Response to further comments made by Dr Clare Halsted dated 6.7.2015

Project	DARTMOUTH PARK ROAD		
Project No.	1393	Sheet	SK-01
Date	11-5-15	Eng.	TC
		Rev.	C
		Chk.

LOWER GROUND FLOOR
= 1:100 @ A3

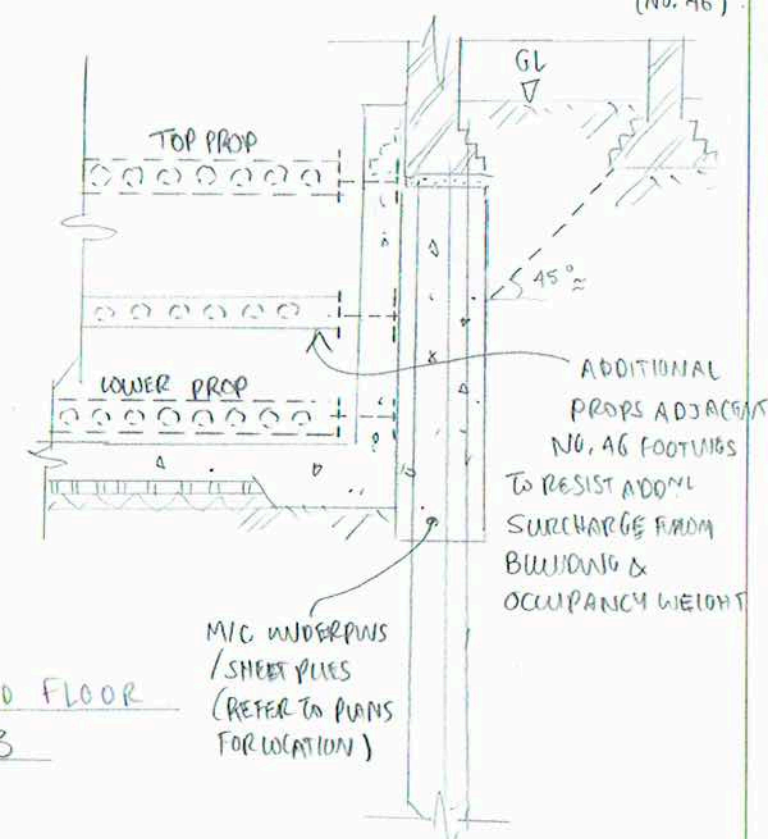
The notional boundary locations are not correctly shown. This is regrettable however it is not material to what is proposed structurally. Furthermore I now attach the engineer's revised drawing with the error corrected.
